Kathleen Baskin, P.E. Director of Water Policy Executive Office of Energy and Environmental Affairs 100 Cambridge Street, 9th floor Boston, MA 02114

Ref: WATER MANAGEMENT ACT PLANED UPGRADE - SWMI

ver below Russell Dam Oct 8 2007

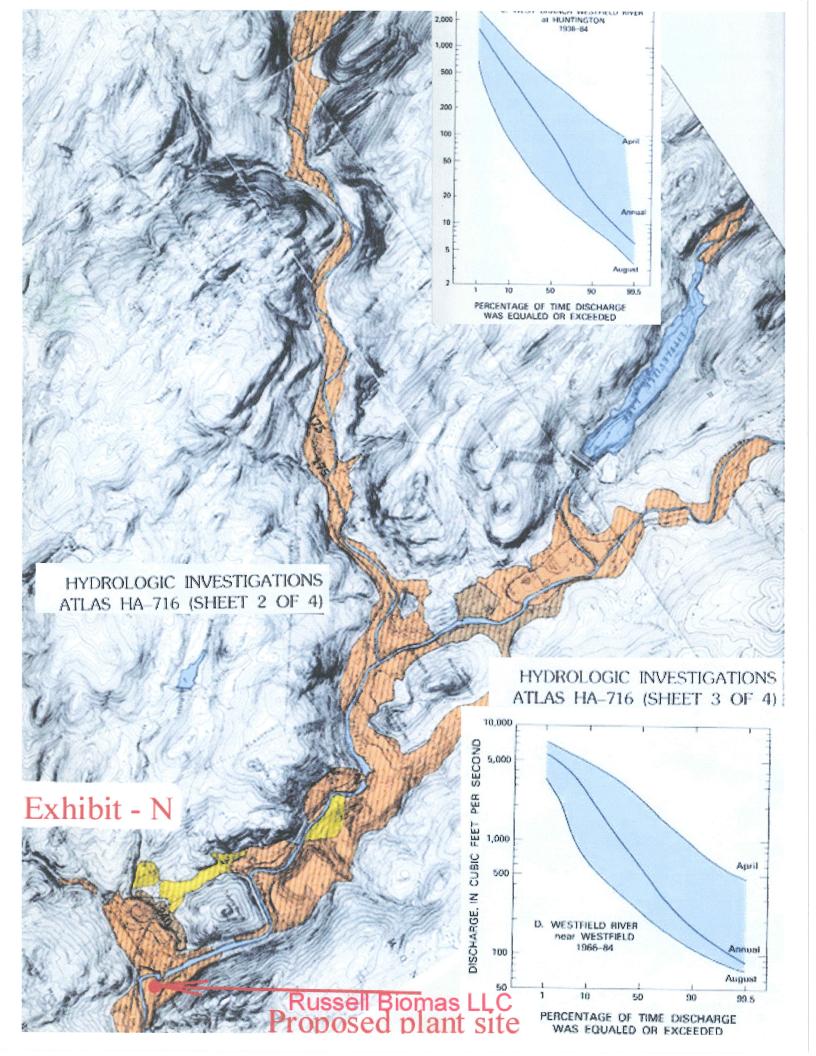
beneath the river bed. Those sediments include sand, gravel, and boulders deposited within the valley by disappear, with water continuing to flow downstream within the sediments. That's the situation in photo Pleistocene glaciers and their meltwater streams. Duning dry conditions, the surface flow may with ally The river's water flows not only on the visible surface, but also within the unconsolidated sediments #1, taken in October 2007.

The proposed Bromass plant in Russell will require the greatest amount of cooling water from th nver during the summer months when the temperatures are highest and the river flows are lowest The amount of water they intend to with draw would have a significant effect on the surface flow during those summer months, particularly during the dry years.

The upstream and downstream section of the river is filled with glacial till of sand, gravel and rocks. USGS 1990 Survey - ATLAS HA -716.
